Exhibit D17

Kwan, Roxanne S

Re: Approval to revise schedule for deliverables 6.3- Investigation and Remediation of Releases Report and 7.1.3. - Groundwater Flow Model Report of the Red Hill Administrative Order on Consent ("AOC") Statement of Work ("SOW") and Comments on Interim Environmental Reports

Conceptual Site Model Topics

Figure 1.1 Estimated Dip Directions in and Around Red Hill

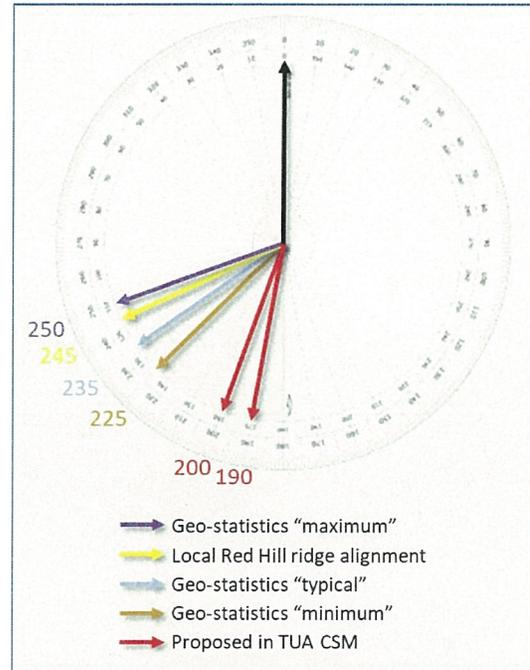
The values for the strike and dip of the lava flows reported by consultants to the Navy (CSM Report, page 5-2: “True dip in the vicinity of Red Hill has been measured at angles of 10–12 degrees, with a strike of 190–205 degrees”) differ from values that were obtained independently by the regulator SMEs via field observation and measurement and geostatistical analysis of barrel log data, which consistently exhibit lower dip values of about 5 degrees and more westerly strike values (Inset Figure 1.1). Although these differences may appear subtle, they are consequential for groundwater flow and potential contaminant transport paths. This is illustrated in Inset Figure 1.2, which presents pathlines calculated using the interim groundwater model, with values for the direction of anisotropy that differ by 10 degrees (particles depicted in red were computed with a more westerly direction of anisotropy reflecting a more westerly assumed dip direction).

Because there is a variety of data sources for dip and strike at Red Hill, it is appropriate to combine the data while considering their representative scales and quality to obtain a best-estimate at the scale of most interest to the fate-and-transport evaluation. Data sources at Red Hill include (a) close-quarters outcrop measurements such as obtained with a compass-clinometer, (b) surveys of visible outcrop from a distance that allow the geometry of a continuous bed-set to be followed for many tens or hundreds of feet, and (c) geostatistical analysis of the barrel log data. The resulting best-estimate derived from combining these lines of evidence can be to some extent corroborated by intersecting the derived plane with a digital elevation model for comparison with features observed in the field (Inset Figure 1.3).

Figure 2.1 Example Comparison of Seismic Profiles and Representation in the Interim Model

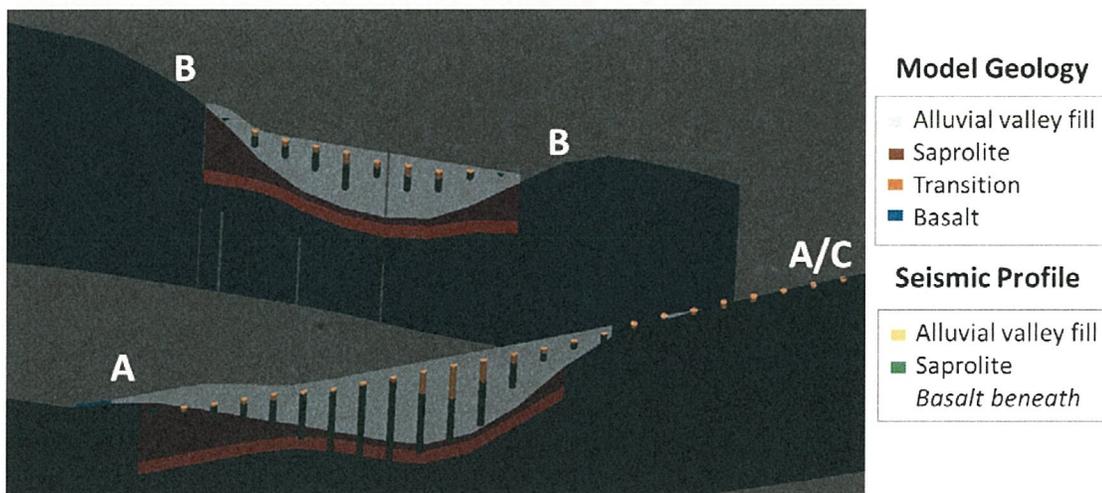
Review of the representation within the interim groundwater flow model files provided for courtesy review by the Navy of the sapolite/basalt interface depths and general trends (i.e., slopes) relative to the axis of the North and South Halawa Valleys suggests the sapolite is likely deeper down-valley and shallower up-valley than represented in the interim model. One consequence is that the point up-valley where the sapolite/basalt interface rises above water table may be more downslope than currently represented. If this is true, the role of the sapolite as a barrier to flow between valleys – particularly in up-slope areas – may be less protective than the current conceptual model indicates (Inset Figure 2.1).

costly, in targeted areas with maximal information benefit to provide (a) seismic velocities needed to better constrain the depth to the saprolite/basalt reflector and (b) interface elevations at key boring locations to condition the geophysical results.

Figure 3.1 Example Figure Illustrating Hydrostratigraphic Features

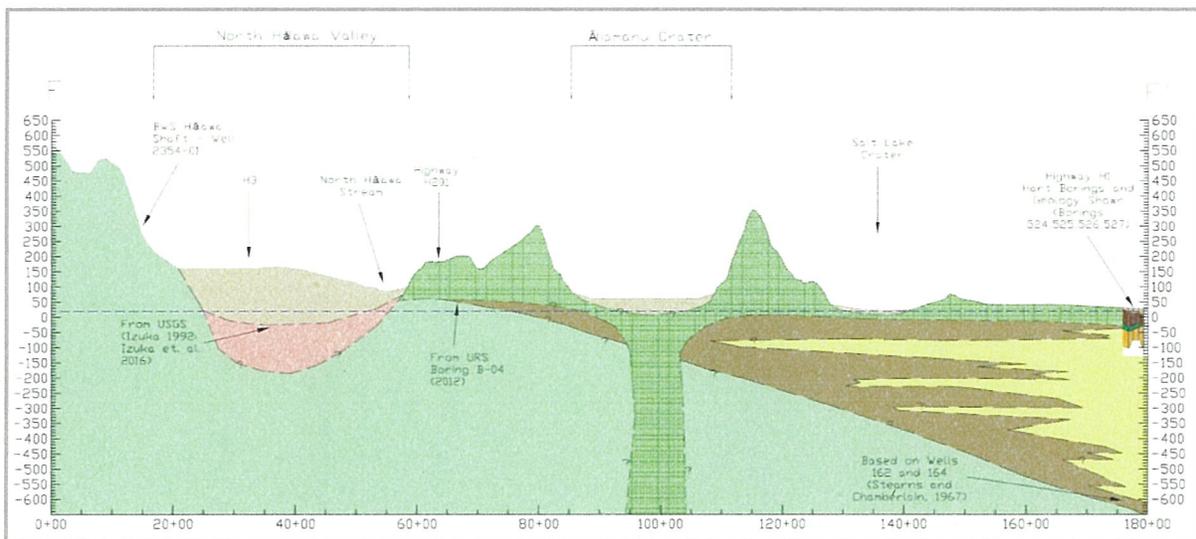
Gradients simulated by the interim flow model, as presented in the GPEC Report and determined from the interim model files provided for courtesy review by the Navy, do not comport well with gradients determined from synoptic data in and around Red Hill facility. While this is in part related to conditions local to Red Hill, analyses conducted using the interim model exhibit high sensitivity to conditions downgradient of Red Hill - specifically, in the area broadly represented by the caprock (GPEC Report Section 5.9). This suggests that although uncertain, because there are insufficient data available to uniquely and accurately specify the distribution and properties of downgradient geologic units, it is important to represent the hydrostratigraphy downgradient of the Red Hill facility as accurately as possible, using as one basis the overarching CSM regarding the distribution and properties of these features (Inset Figure 3.1).

Available information must be interpreted in the context of the CSM and AOC to provide an appropriate representation for flow and transport modeling. The solution to this problem likely lies in two parts: First, re-interpretation of the available data, and expanded use of sensitivity analysis and model calibration to help identify probable geometries and properties, including for example extending the saprolites down-valley, and differentiating Honolulu volcanics from surrounding sediments. Second, based on the anticipated results of sensitivity analyses conducted with this updated representation of

Figure 5.1 Schematic of Recorded and Simulated Inflows

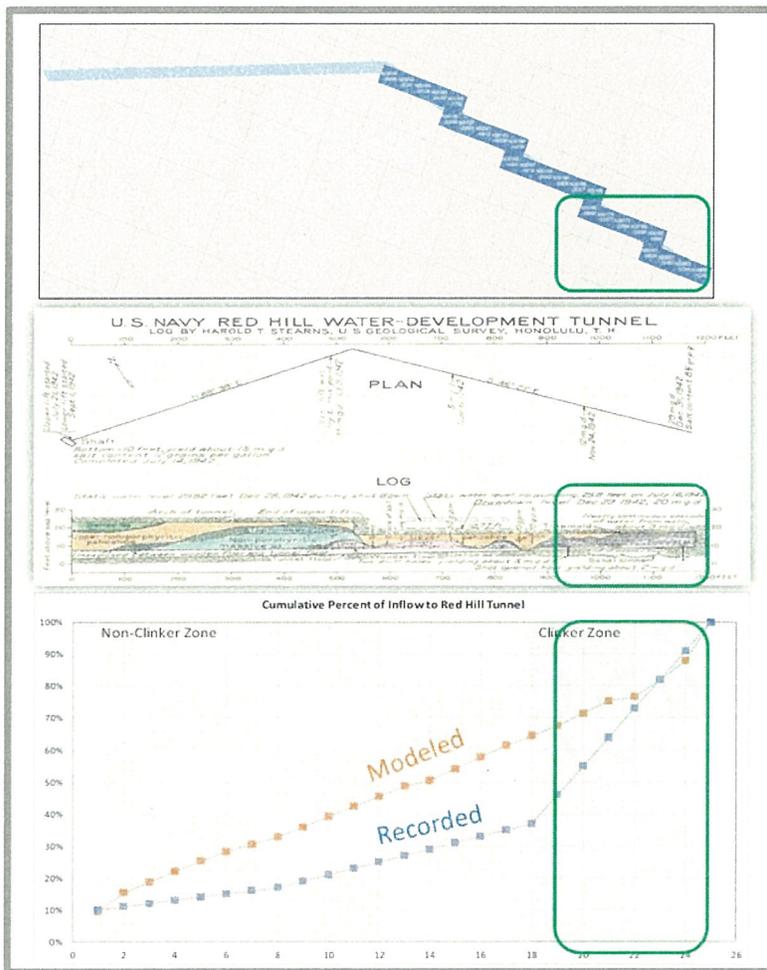
The interim groundwater flow model does represent Red Hill shaft as a linear quasi-horizontal feature rather than at a single vertical point, which is appropriate. However, the distribution of inflows to the eastern tunnel extension simulated by the interim model as determined from the model files provided for courtesy review by the Navy does not appear to match the inflow pattern encountered during tunnel construction (Inset Figure 5.1). During construction, a clinker zone was encountered that contributed more than 60% of the flow to the tunnel whereas the interim model simulates uniform inflow along the tunnel. This difference highlights two issues: first, there is heterogeneity present on a scale of many tens

to hundreds of feet that is not well understood nor represented in the interim model; second, the extent of capture developed by the tunnel may be more head-dependent than represented in the interim model. That is, the capture zone under high water level conditions may be dominated by seepage from this clinker at the end of the east tunnel, but under low water level conditions may be dominated by drawdown within the vertical shaft itself. Sensitivity analyses conducted with the interim model indicate that the model exhibits sensitivity to the potential presence of a clinker zone (GPEC Report Section 5.9).

The final CSM and model should make a greater effort to evaluate the possible role of these heterogeneities – in particular, as an illustrative example, the Red Hill tunnel clinker – on calibration, zones of contribution, and contaminant transport. This may be accomplished for example by evaluating the zone of contribution under high water level conditions dominated by tunnel seepage, and under low water level conditions dominated by active pumping at the Red Hill shaft.

Figure 6.1 Example Comparison of Pairwise Head Differences from Synoptic Data with Simulate Head Differences from All Interim Models

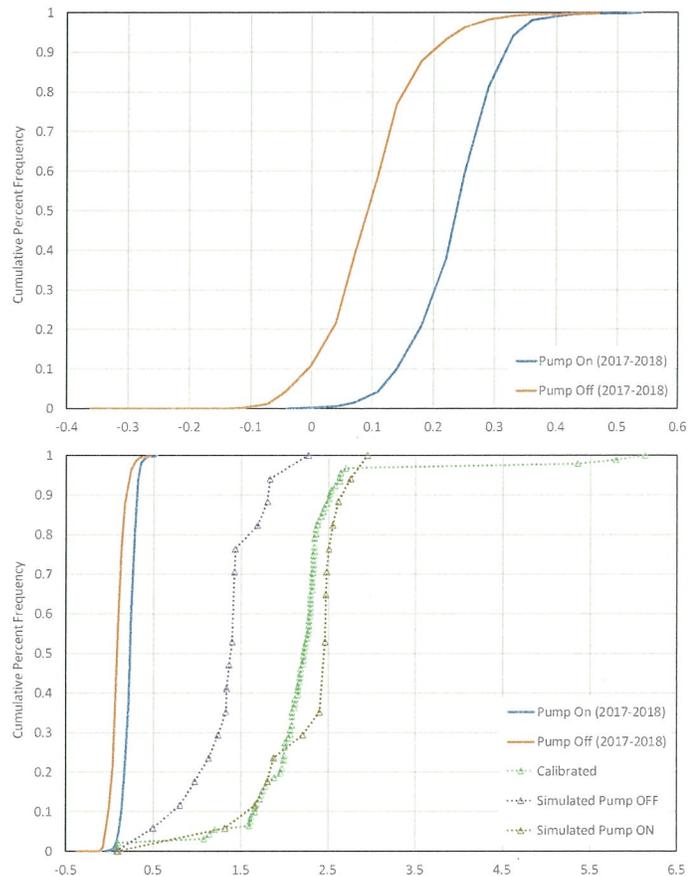
Hydraulic gradients determined from measured data are generally flat in and around Red Hill. On most occasions, gradients are to the southwest at a low slope, but occasionally they appear to be to the northwest and possibly north. The interim model outputs presented in the GPEC Report do not closely reproduce the magnitude or direction of these gradients. Flow in the calibrated interim model is dominantly Mauka-to-Makai, and most of the sensitivity-derived alternative models demonstrate flow toward Red Hill shaft at gradients that are 10 to 100 times higher than measured values. Although the sensitivity analyses do present a range of simulated gradients (GPEC Report Section 5.9), the distribution of simulated gradients across all models that were provided for courtesy review by the Navy does not match closely values derived from the synoptic data (Inset Figure 6.1).

The final CSM and model should focus on analyzing recent high-quality synoptic data to the extent possible, and down-weight analyses based on older data. Despite difficulties preparing water level maps, pairwise head-difference plots can show the effects of pumping on gradients and the frequency and magnitude of gradient reversals. Steady-state model calibration should focus on demonstrating a match

with regional patterns and with representative local gradients under pumping and non-pumping conditions. This combination is required to demonstrate that the model is useful for near-field transport to understand the available groundwater data, and for developing predictions of capture zones for Red Hill shaft and Halawa shaft to help evaluate risk and mitigating responses or strategies. Transient calibration will provide information on T, S, anisotropy, and possibly on the geometry of features such as the saprolite but is not a substitute for obtaining reasonable mean-centered correspondence to the measured gradients (or pairwise head differences).

Figure 10.1 Example Figure Illustrating Variable Discharge to Pearl Harbor

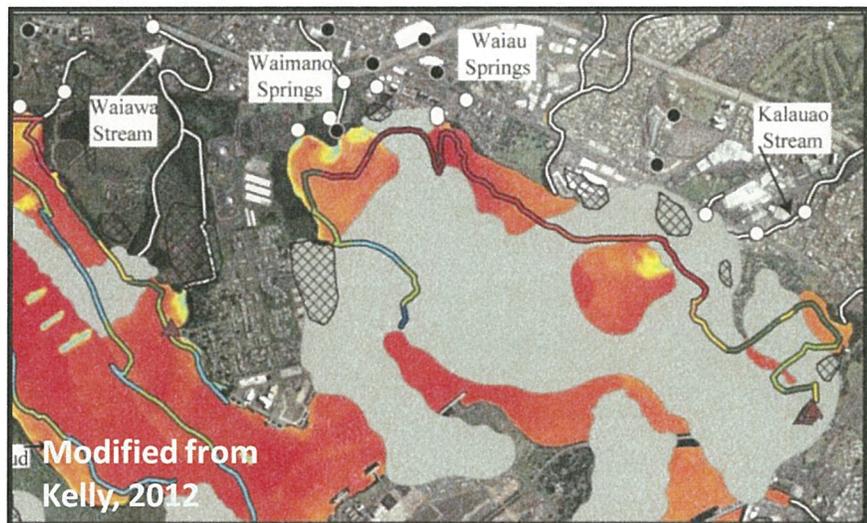
Gradients simulated by the interim flow model do not comport well with measured gradients in and around Red Hill facility. While this is in part related to conditions local to Red Hill, the interim model exhibit high sensitivity to conditions downgradient of Red Hill. The interim model represents the downgradient discharge (outflow) from the model to the saline water bodies (Pearl Harbor Estuary and offshore areas south of Pearl Harbor) via a general head boundary (GHB) with some areas exhibiting intervening high-conductivity cap rock (GPEC Report Section 4.4). The GHB allows flow based upon an ascribed elevation and an intervening resistance between the boundary and the aquifer. In this configuration, groundwater is simulated to preferentially flow to the eastern part of Pearl Harbor Estuary. However, muds and volcanic ash on the bottom of Pearl Harbor may impede flow leading to more flow from Moanalua Aquifer to the Waimalu Aquifer. Flow from the Moanalua Aquifer to the Waimalu Aquifer where spring systems and large pumping centers create significant drawdown could result in a flow path beneath the Red Hill facility to the northwest.

The approach to simulating the groundwater flow to the Pearl Harbor Estuary and the southern offshore regions needs further work. Although uncertain in extent and character, it is important to represent the downgradient outflow conditions as accurately as possible, using as one basis the CSM regarding the distribution and properties of these features, and also other sources of information (Inset Figure 10.1).

The solution likely lies in two parts: First, re-interpretation of the available data, with expanded use of sensitivity analysis and model calibration to help identify probable geometries and properties. Model refinements may include using multiple layers to simulate the caprock and include older alluvial sediments and the muds and tuffs that blanket the floor of Pearl Harbor. Second, based on the anticipated results of sensitivity analyses conducted with this updated representation of these features, consideration should be given to methods of data collection to better constrain the likely presence, extent and properties of these features.

Figure 9.1 Example Terminal Electron Acceptor (TEA) Map – Dissolved Oxygen

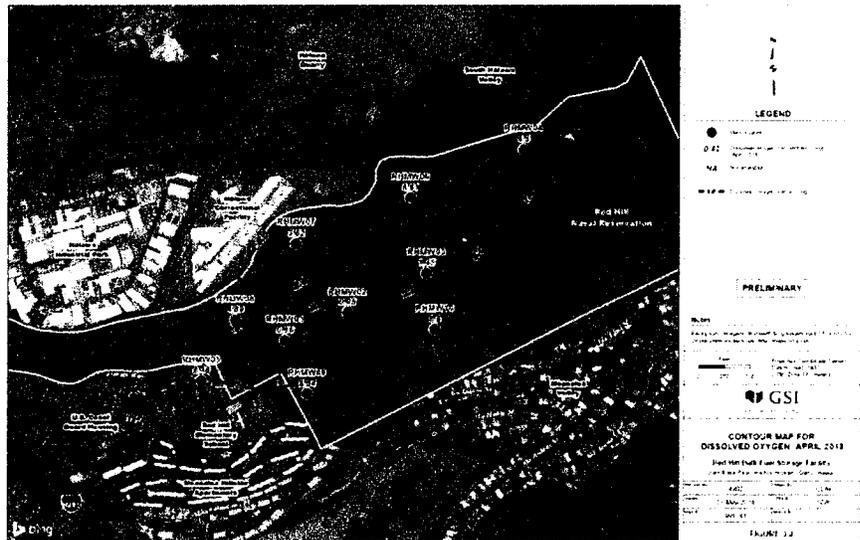
Example 2: Independent analyses of TEA data presented and discussed in CSM Report Section 7.3.2 and Appendix B.4 and GPEC Report Figure 6.3 as indications of natural attenuation (e.g., Inset Figure 9.1), dissolved phase contaminant detection frequency and distribution (inset Figure 9.2), and hydraulic gradients, suggest transport occurred not just to the southwest but also to the northwest and possibly northeast of the facility. Example 3: The distribution and concentrations of general chemistry data (i.e. major ions, specific conductivity, and pH) show a poorly-mixed system inconsistent with the Navy CSM of robust flow from upslope recharge areas to Red Hill Shaft. The chemistry is highly variable with chloride concentrations spanning over an order of magnitude and is more suggestive of sluggish down-slope flow and compartmentalization (inset Figures 9.3 and 9.4).

Before developing the transport model, it is important that the CSM encompass reasonable interpretations of available water quality data. The CSM should, at this stage, allow for “alternative hypotheses” of at least equivalent likelihood of LNAPL impact to groundwater versus the current hypothesis of there having been no impacts. The final groundwater flow model, when it reasonably represents hydraulic gradient directions and magnitudes in the vicinity of Red Hill ridge, would be anticipated to underpin a contaminant transport model that demonstrates a reasonable match historical sample results (contaminants and TEAs, etc.), thereby demonstrating that the model is useful for near-field transport to understand the available groundwater data, and for developing predictions of contaminant transport and fate to help evaluate risk and mitigating responses or strategies.

Figure 9.3 Image of Chloride Concentrations Sampled at Wells

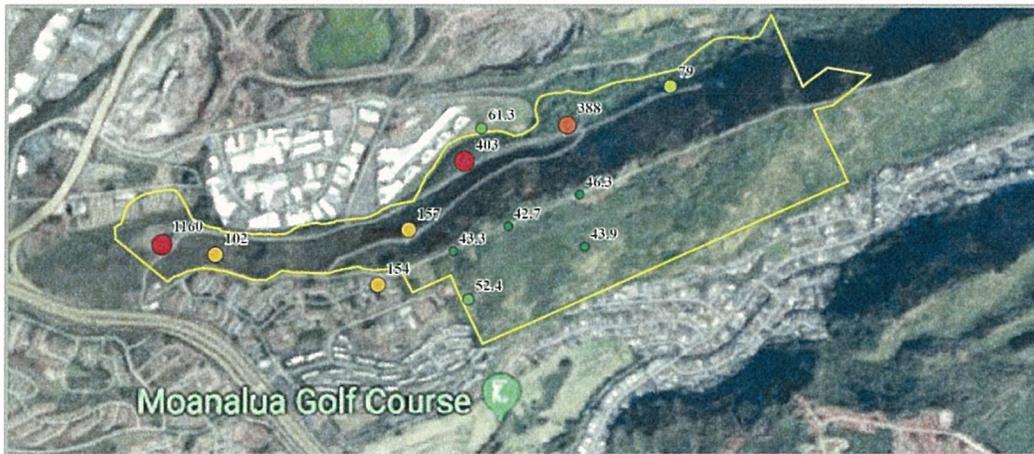
Interpretations of water quality data presented in the CSM Report and GPEC Report are in places non-conservative, and conflict with other lines of evidence and with conclusions reached by regulator SMEs. Example 1: The Navy consultants dismiss some detected results out of concerns for data quality (CSM Report Section 7.2 and Appendix B.7). Though in some instances justified, these concerns do not address all detected results, and from the regulatory perspective, any reported detections that are not qualified are evidence of impacts. Example 2: Independent analyses of TEA data presented and discussed in CSM Report Section 7.3.2 and Appendix B.4 and GPEC Report Figure 6.3 as indications of natural attenuation (e.g., Inset Figure 9.1), dissolved phase contaminant detection frequency and distribution (inset Figure 9.2), and hydraulic gradients, suggest transport occurred not just to the southwest but also to the northwest and possibly northeast of the facility. Example 3: The distribution and concentrations of general chemistry data (i.e. major ions, specific conductivity, and pH) show a poorly-mixed system inconsistent with the Navy CSM of robust flow from upslope recharge areas to Red Hill Shaft. The chemistry is highly variable with chloride concentrations spanning over an order of magnitude and is more suggestive of sluggish down-slope flow and compartmentalization (inset Figures 9.3 and 9.4).

Figure 10.1 Net average temperature greater than the Red Hill Shaft (RHMW2254-01; in degrees Celsius). Like other MNA-related parameters, the elevated temperatures are generally along the Red Hill Ridge and to the west and north. Data source: USGS Synoptic Data, 2018.

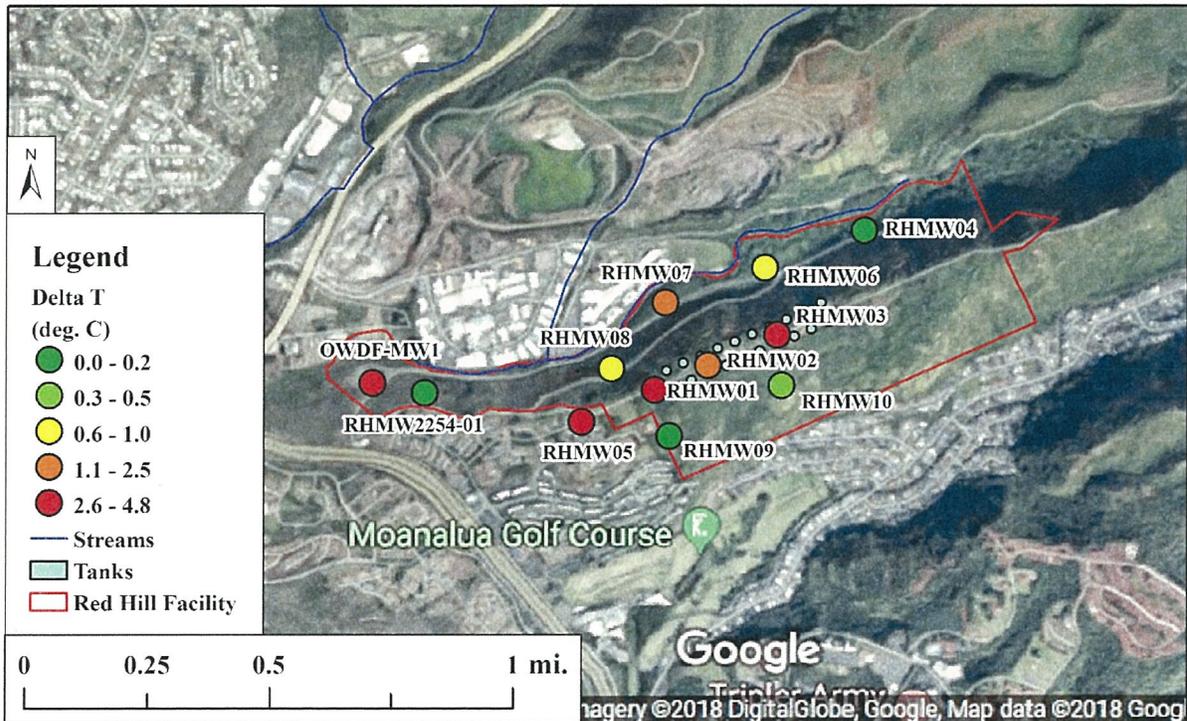
In terms of the depth of migration of LNAPL from the Tank 5 release in 2014, the primary analysis relied upon in the CSM is the thermal profile at RHMW02, with backup support from chemistry considerations. A net positive temperature profile indicates the effects of exothermic biologic reactions and is affected by a variety of subsurface factors. In general, that relationship can be useful to infer lateral distributions of LNAPL biodegradation (e.g., Figure 10.1 above) but is highly uncertain with respect to the LNAPL vertical distribution. In many cases, as shown in the example thermal profile in our August 15, 2018 presentation (Slide 28), the LNAPL vertical mass distribution cannot be inferred from the temperature profile. A review of data in the 2007 Red Hill investigation report (DON, 2007) shows that the rock cores were evaluated for evidence of petroleum contamination by checking for odor and by screening with a photo-ionization detector. No evidence of petroleum contamination was found. The groundwater temperature in RHMW03 measured during sampling has remained unchanged at about 26.5 °C since first sampled in 2005 to the present, indicating that the temperature profile recently measured by the Navy likely existed when RHMW03 was first drilled. As a consequence, this locally-elevated temperature does not directly relate to the migration or distribution of LNAPL arising from the 2014 release but

relates (at least, predominantly) to past releases. Also, there has been no release of consequence since 2005 that would cause LNAPL to enter the zone indicated by the thermal anomaly in RHMW03. In summary, the Navy's contention that the thermal profiles in the tunnel wells show that the LNAPL is constrained above the water table is not supported by the available data. We believe the Navy technical team needs additional data to validate its interpretation of LNAPL transport around Tank 5 from the 2014 release, as it is a fundamental cornerstone to the remainder of the LNAPL F&T considerations. At a minimum, the Navy should include several Hawai'i or equivalent geology examples where the LNAPL source distribution has been definitively interpreted by this method and independently validated through subsurface data demonstrating that actual LNAPL source distribution (e.g., core sampling, downhole investigation, etc.). Alternatively, it would be useful to consider a site specific data collection program to verify the LNAPL source distribution around Tank 5 and possibly other key locations. By whatever approach, additional lines of evidence are needed to verify the assumptions relative to fate and transport of the 2014 release.

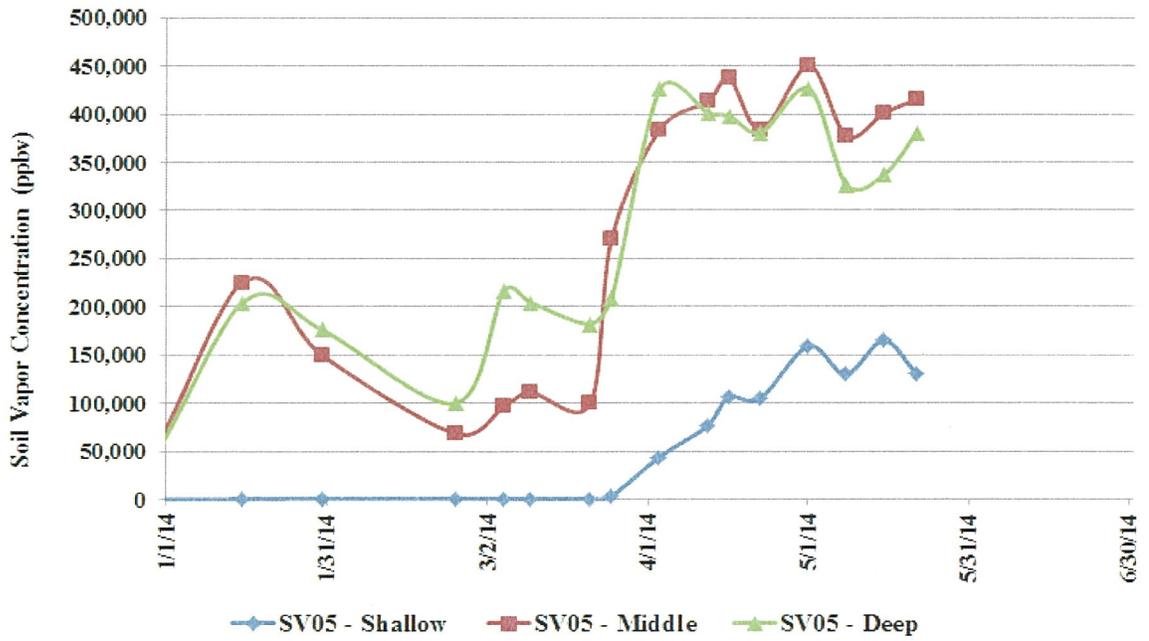
The in situ vapor probe response around Tank 5 in the timeframe following the 2014 release can be interpreted as indicating that the primary vapor migration may have been to the northwest side of that tank and not in the direction of RHMW02 (see Figure 10.2 below). Actual LNAPL transport outcomes beneath Tank 5 in 2014 below the vapor probes is unknown; the conservative assumption based on this limited data is that transport was potentially to the northwest and is not represented with any certainty by the spatially limited monitoring well array.
